Barton Street, Barangaroo

Road Safety Audit

Detailed Design Stage

JN21019_Report01 Rev02 - JMT Barton

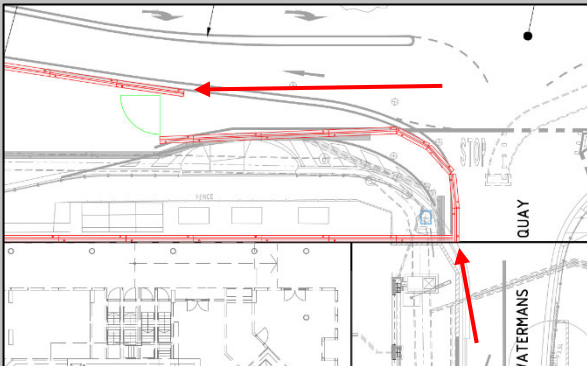
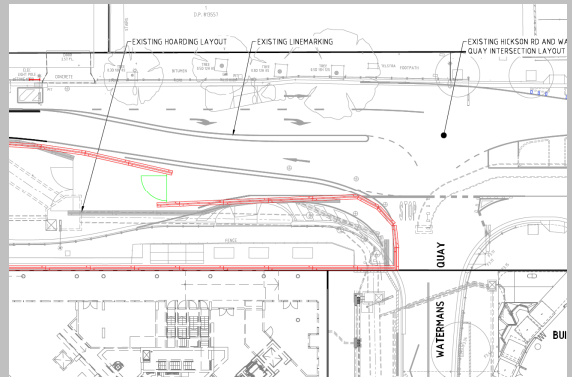
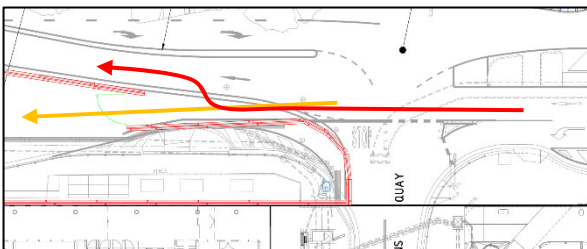
Item	Safety Hazard Finding	Frequency	Severity	Level of Risk	Project Manager Response
1. Hoarding/Barrier Terminals	<p>There are hoarding/barrier terminals in the clearzone of the travel lane.</p> <p>There is a risk that an errant vehicle may impact the blunt end of a hoarding/terminal resulting in injury to vehicle occupants.</p> 	Occasional	Serious	High	<p>This has been addressed with adjustment to hording to include taper and separation from Hickson Road travel lane as per the recommendation of the Road Safety Audit, as indicated below</p>

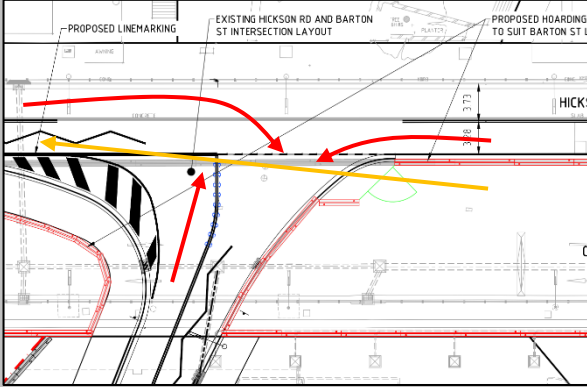
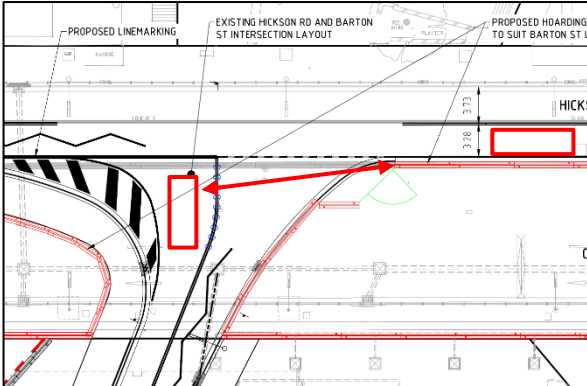
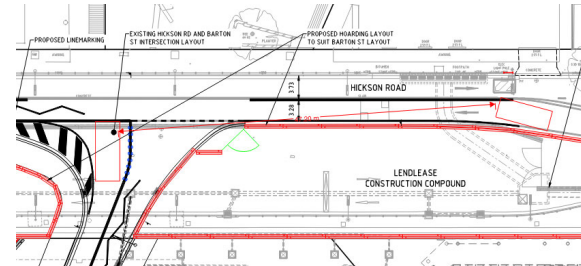
Item	Safety Hazard Finding	Frequency	Severity	Level of Risk	Project Manager Response
3. Vehicle Exit	<p>There is a construction exit at the kerb return of an intersection.</p> <p>There is a risk that a motorist (northbound, southbound, eastbound, or turning) may not sight an exiting construction vehicle resulting in side impact or sideswipe collisions.</p> 	Probable	Minor	High	Traffic controller at this location to ensure vehicles exit safely. Construction vehicles will only be instructed to depart the gate by traffic controllers when there is no oncoming traffic on Barton Street and is safe to do so.

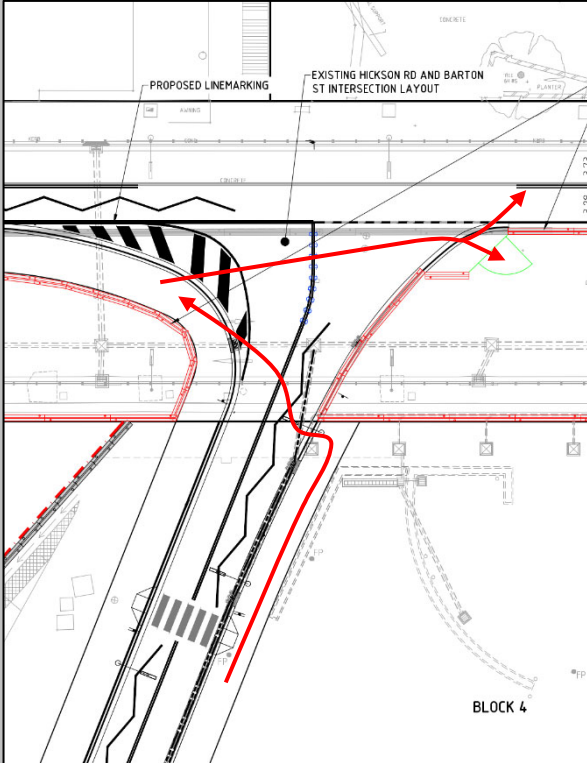
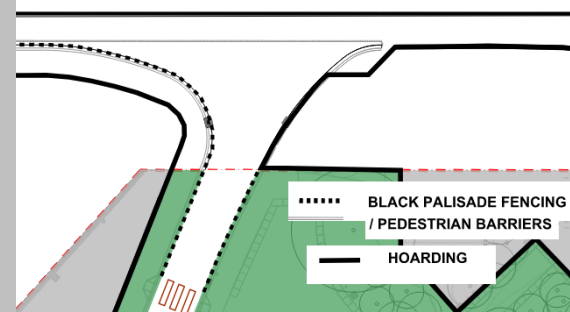
Item	Safety Hazard Finding	Frequency	Severity	Level of Risk	Project Manager Response
5. Pedestrian Access	<p>There is pedestrian access proposed beyond the pedestrian crossing point, with no safe pedestrian route provided.</p> <p>There is a risk that a pedestrian may continue past the pedestrian crossing and enter the travel lanes resulting in a pedestrian-vehicle collision.</p> <p>There is a risk that a pedestrian may continue south along Hickson Road entering the construction access or walking around the proposed hoarding on Hickson Road resulting in a pedestrian-vehicle collision.</p> 	Occasional	Serious	High	<p>Pedestrian barriers to be in-place to prohibit pedestrian movements at this location in line with the recommendation of the Road Safety Audit, as indicated below</p>

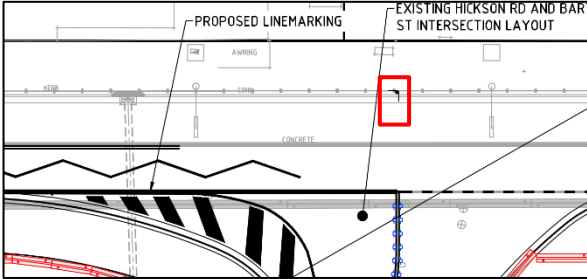
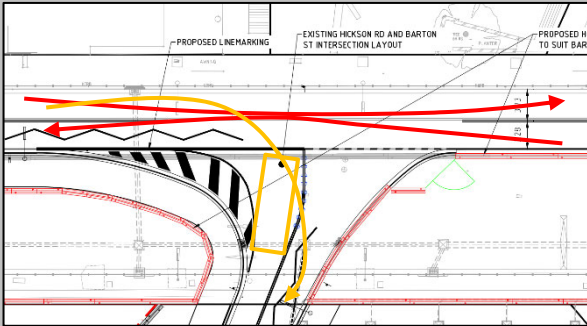
Item	Safety Hazard Finding	Frequency	Severity	Level of Risk	Project Manager Response
6. Street Signage	<p>There is a sign proposed on the eastern extent of the intersection that hangs into the travel lane.</p> <p>There is a risk that a vehicle may impact overhanging signage resulting in vehicle damage.</p> <p>There is a risk that a motorist may swerve to avoid a sign resulting in head on collisions with oncoming vehicles.</p> 	Occasional	Limited	Low	Noted as a low risk. Deemed acceptable.

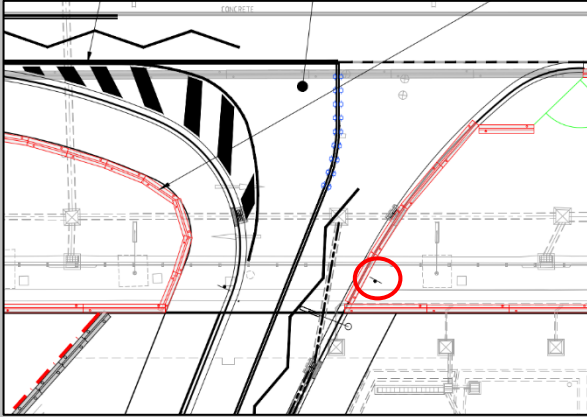
Item	Safety Hazard Finding	Frequency	Severity	Level of Risk	Project Manager Response
8. Speed Zones	There are no speed limit signs shown. There is a risk that motorists may travel at a higher speed than the design allows for, including construction setups and the speeds expected by construction workers, increasing the frequency and severity of crashes.	Improbable	Minor	Low	This will be managed through clear signage.
9. Signage	There is no signage provided on the plans. There are signposts shown but it is unclear to the audit team of the proposed sign face. In particular, there is no intersection priority signage shown in close proximity to the intersection hold line, and there is a sign shown inside of the hoarding. No further assessment has been carried out.	Note			This will be managed through clear signage.
